Tuesday, May 11, 2021
Medway Planning and Economic Development Board
155 Village Street
Medway, MA 02053

SALMON/WILLOWS ARCPUD FIELD CHANGE:

PUBLIC BRIEFING - BOUNDARY LANE PRELIMINARY SUBDIVISION PLAN:

MEDWAY PLACE SITE PLACE SITE PLAN:

C1.00

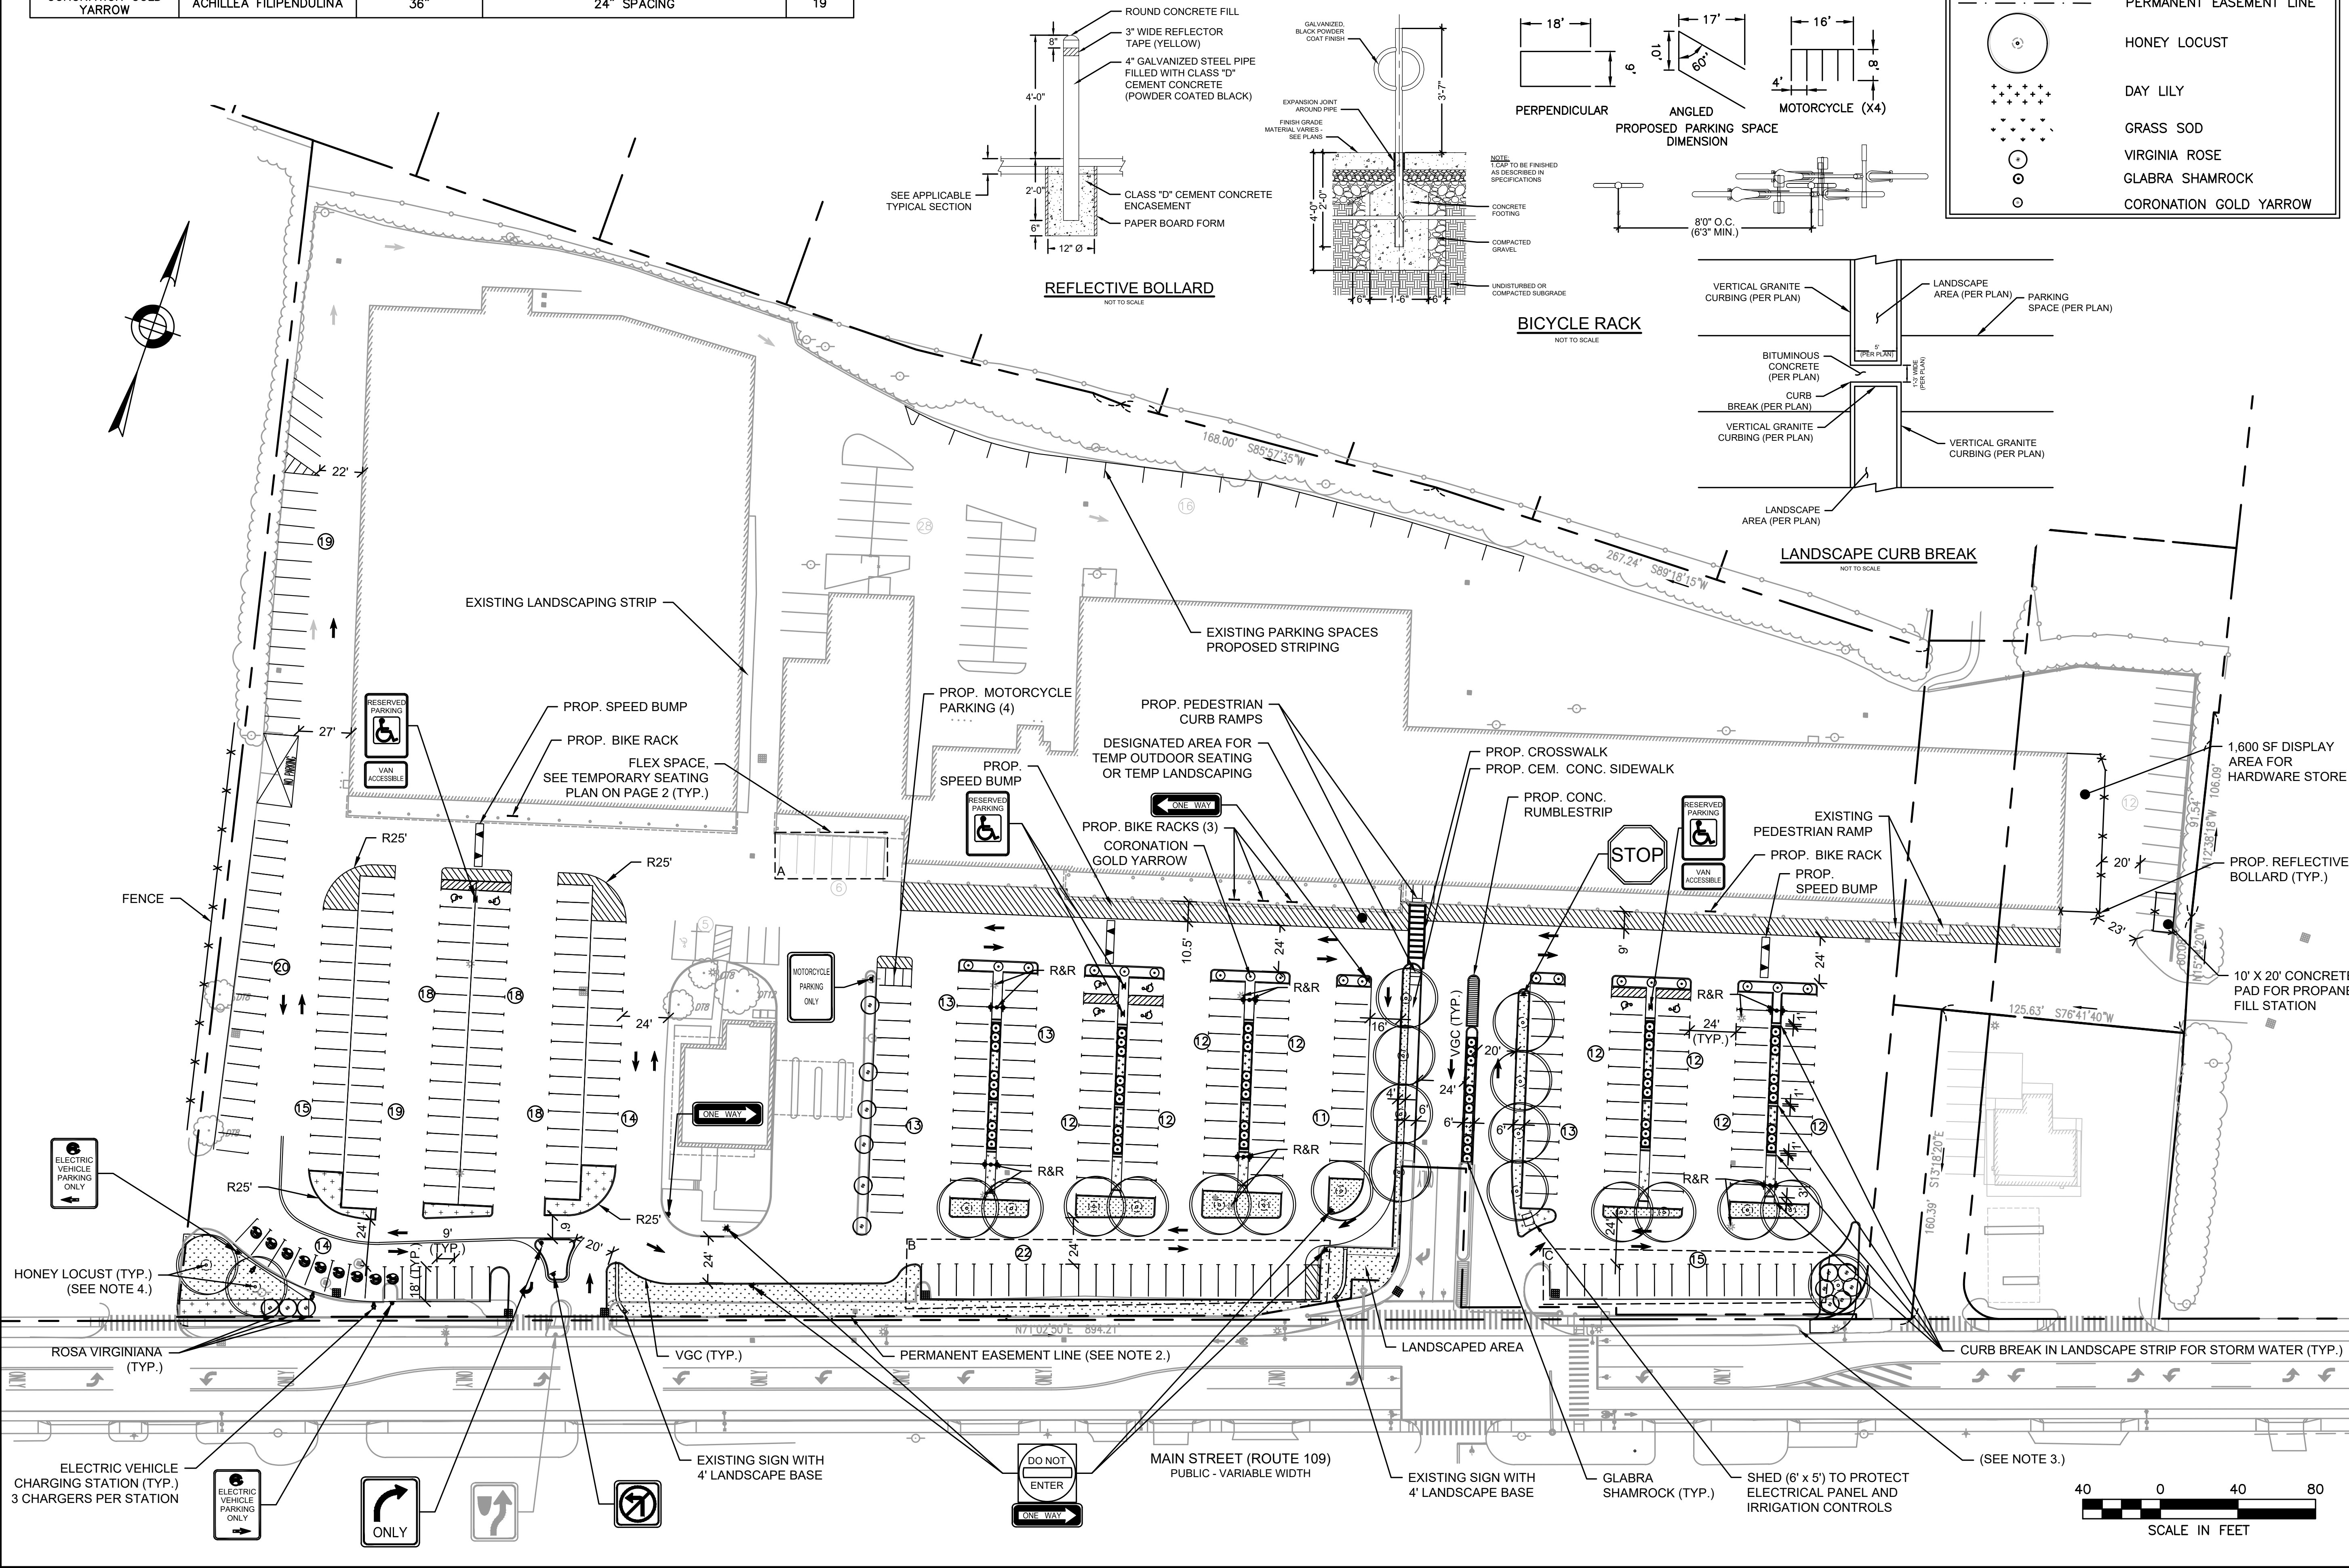
The Engineer next discussed the boxes A, B and C as shown on the plan. These are temporary flex spaces. Box A is in front of Pj's. These temporary spaces could be for outdoor seating or

planters. The Board likes the idea of outdoor seating. The Board wants to make sure that whatever is proposed in this area will stop vehicles. The applicant sees this as something that is bolted into the ground and could be changed depending on the season (summer and winter). These would be pop-up areas. The Board wants this a permanent safe solution and not temporary.

The configuration of the parking at the Bank needs to be looked at since it does not work well in the current location. Some of the design needs to take into consideration the MASS DOT plan. This includes some of the items such as the entrance requirements and some of the sidewalks. There has been the inclusion of speed bump. The entrance would include proper dimension as discussed with Fire Chief. This will be 20 ft. into the newly designed parking area. There will be electric car charging spaces. The B and C Box areas have food truck parking to attract temporary businesses. The Board likes the idea of the food truck area. The plan also shows an outdoor display area for the new hardware store. There will also be a 10 x 20 ft. propane fill station. The electrical equipment would be stored in a shed. There would be bike racks, motorcycle spaces and signage throughout the site. The Board was made aware that there was a note from DRC relative to their recent meeting. The next item discussed was the fence on the west side of the site. It was encouraged to be sure to maintain the pedestrian access. The Board would like to see a split rail fence instead of a white glossy stockade fence. The goal is to link both properties for the benefit of the shoppers. The applicant has not looked at the construction aspect of this project. There needs to be a plan put in place with a schedule. The Board would like to see the curbs put in place now. There needs to be a centralized trash plan. Currently there are 38 dumpsters in the back area. There was a question if the 433 parking spaces are really needed in this plaza. The applicant will look at this and needs to review the leases regarding the parking requirements for the tenants. This is a contractual issue with some of the tenants. The applicant was informed that at the recent town meeting there was a zoning bylaw passed regarding the vehicle charging stations and video signage. It was recommended that the applicant look at this bylaw. It was noted that the existing monument signs require 3 ft. of landscaping at the base of those signs. The applicant was informed that the caliper of the trees need to be noted on the plan. The plan shows 22 trees but that falls short of the requirement based on the site plan rules and regulations.

- There is requirement maintenance plan for landscaping.
- There should be signage standards going forward for tenants.
- There needs to be perimeter landscaping detail to show screening of the parking.
- The trees on plan need to show caliper and height.
- There should be noted employee parking.
- There needs to be more information about the display area.

- It is unclear on what is proposed for pavement restoration.
- It is recommended that this area is milled, there is an overlay of the entire parking lot area.
- There were no details on the charging stations.
- There should be a plan for the island with drainage improvements and utilities.
